IAEA MISSION ON PARTIAL COLLAPSE OF TURBINE HALL ROOF OF UNIT 4

**Review of activities performed by ChNPP and analyses of perspective causes of
the Unit 4 turbine roof failure.**

Chernobyl NPP, Ukraine

03–07 June 2013

Figure 1 Turbine Building outside view of area of collapsed wall and roof section

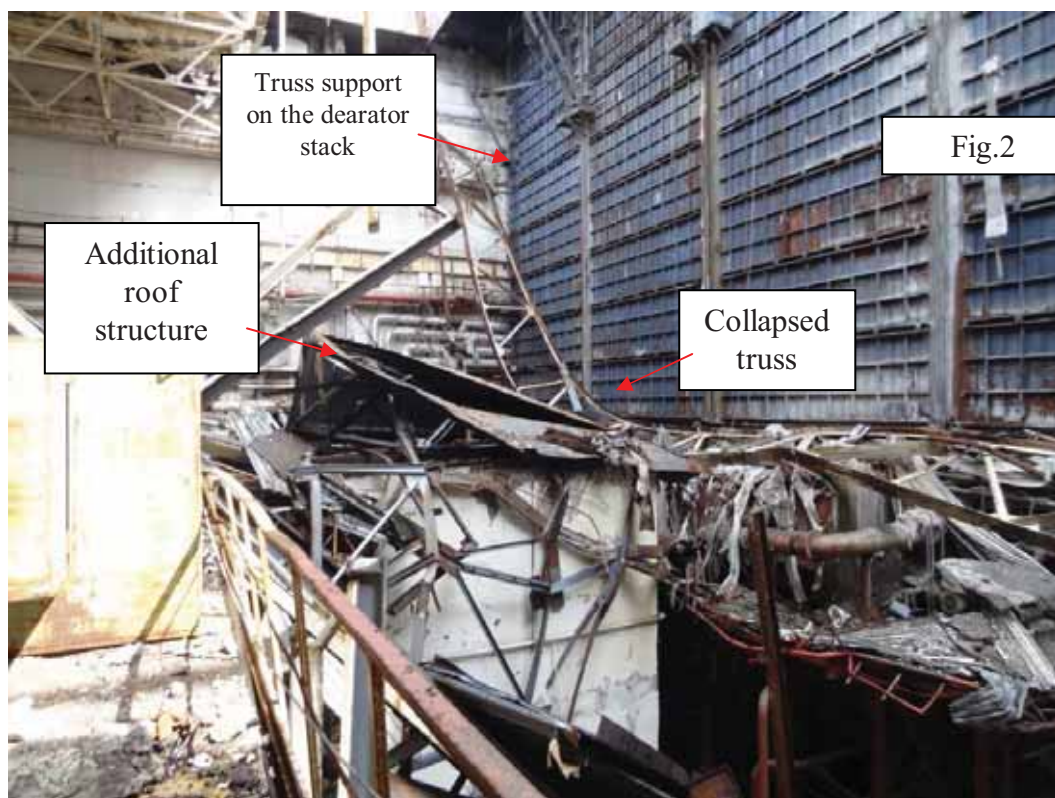
The collapse of the part of the Chernobyl NPP's Unit 4 Turbine Hall roof in axes 50-52 has occurred 12.02.2013 (Figure 1). The survey conducted after the collapse showed that the failure of the truss along gridline 50 (Figure 2) was the cause of the collapse. Truss failure resulted in the collapse of the hinged wall roof panels and additional roof constructions, installed in 1988 above the roof originally constructed in 1983.

During the roof truss failure, its bearing node on the deaerator stack structure on row B side wasn't destroyed. As a result, the fallen roof truss is partially supported and hanging to the deaerator stack structure.

Figure 7 Damages to ChNPP generation II structures (Units 3 and 4) as a result of the accident

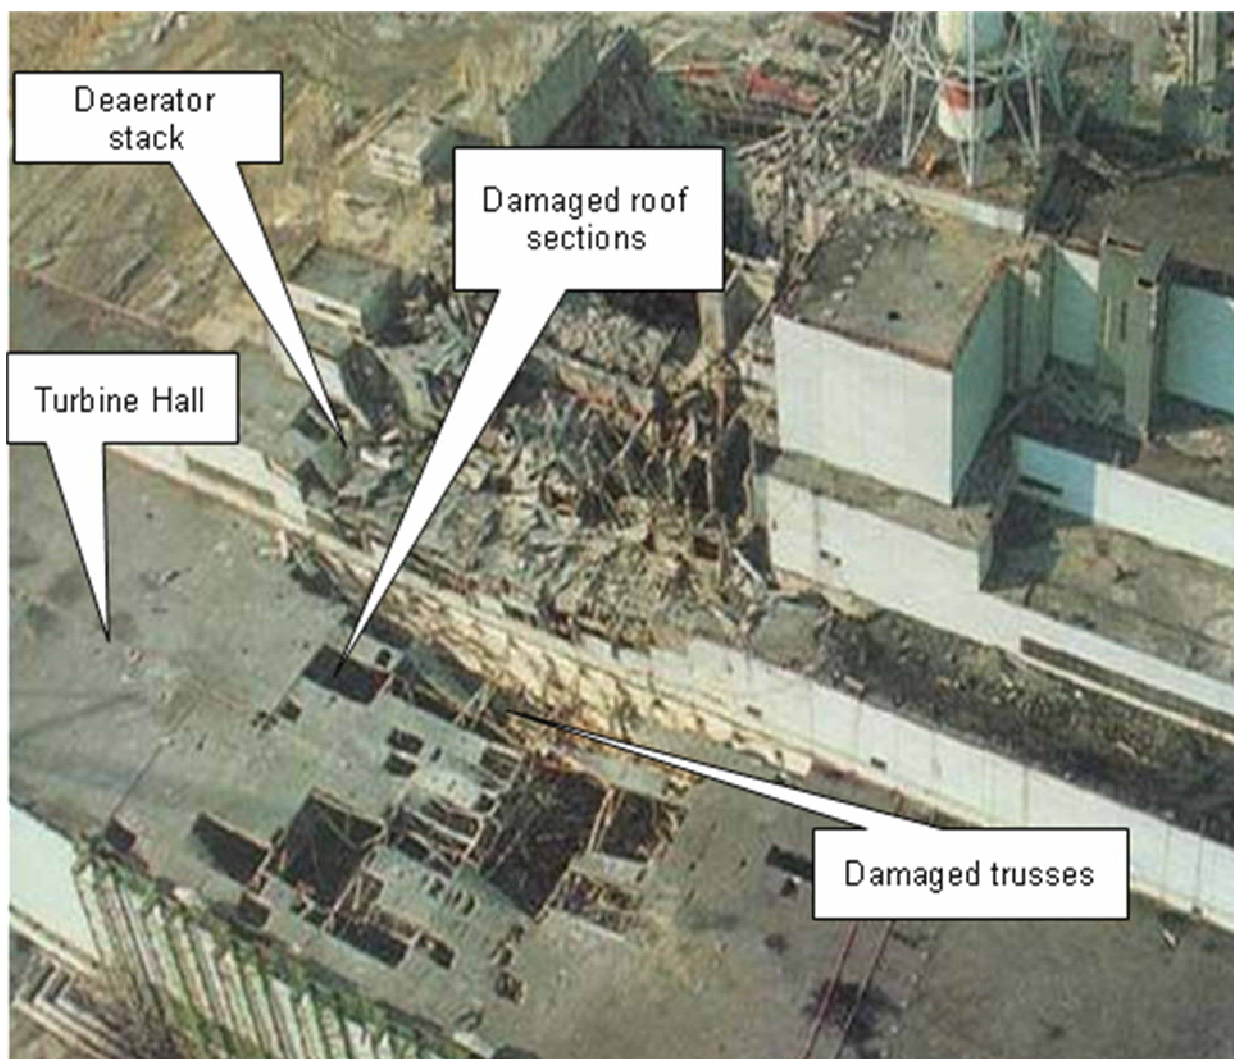
During the 26.04.1986 accident not only Reactor Building, but also some Deaerator Stack and Turbine Hall structural elements were seriously damaged (Figure 7).

The Turbine Hall roof was not only damaged, but also highly contaminated with radioactive particles ejected during reactor explosion. The Deaerator stack structures (Fig. 8), being the supporting structures for the Turbine Hall roof trusses were significantly damaged at places. Especially seriously were damaged the roof elements in gridlines 40-50, i.e. in the area closely adjacent to Unit 4 Reactor Building.

Figure 9 Transverse section of second roof structure in “low” roof area

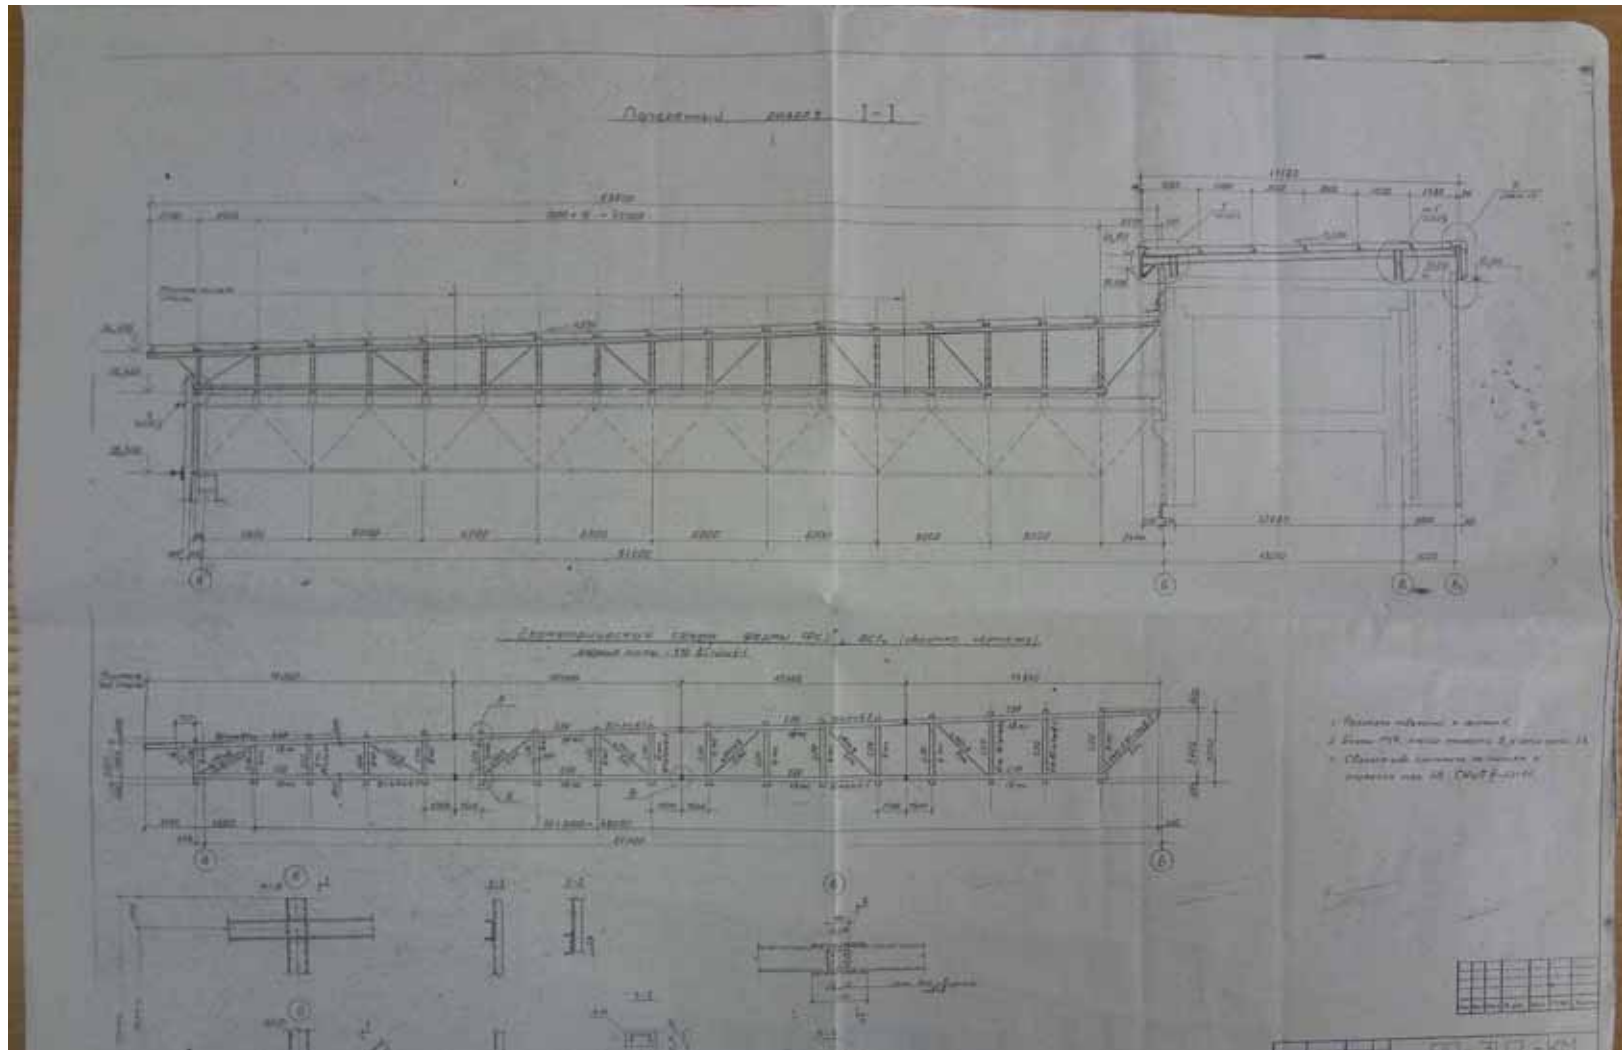
Additional "low" roof was arranged in the area, where the damage severity was less. In this zone original trusses have been kept as the supporting structures for covering. New construction has been installed on the axes of these trusses above the existing roof slab, which included additional metal frames, on which the roof of flat steel sheets stacked overlap has been arranged (Figure 9). In the longitudinal direction the joints between the sheets has been arranged using the roofing iron strips. Also, junction of additional "low" roof to the deaerator stack was covered using the flat strip. There is no data about presence of moisture-proof seals or other means for roofing sheets sealing.

The design calculations that should establish the availability of structural resource to support the second roof and whether this included any reduction of original design snow load are unknown.

It would be prudent to try (again) to obtain full set of as-build design drawings and design calculations from the Designers of Record from 1983 and designer of construction of additional roof performed in 1988 (possibly with involvement of the General Designer - VNIPIET Institute from St. Petersburg). Such design information would significantly contribute to the completeness of actual data required for the further analysis of the turbine hall roof stability and understanding of the conditions impacting on engineering estimate of the life cycle.
